Access Compliance Report

Public Rights-of-Way

(Curb Ramps)

Intersection ID: 8592	Main Street: PERIWINKLE_HILL_AV	Cross Street: IKEA_BV	Location:	E
ADA ID: FD2BA1D31254	Ramp Type: Directional1	Initial Pass/Fail: Pass	Overall Compliance: No	Severity Score: 0

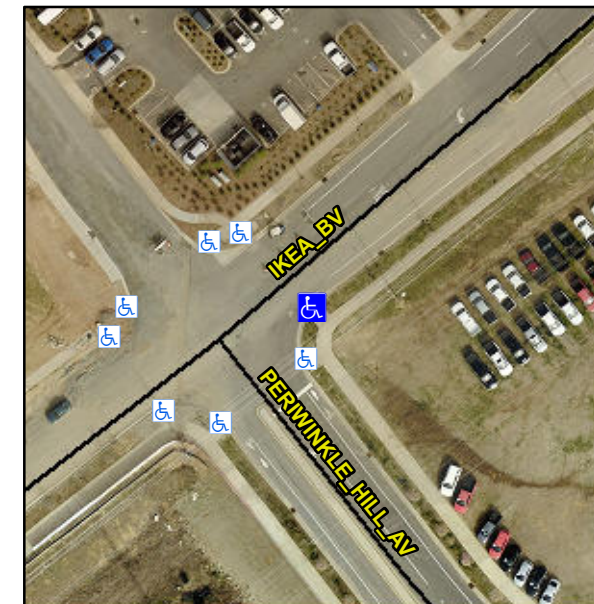
**Remove & Replace Entire Ramp.
Gutter Ponding Observed.**

R304.5.3, R302.7
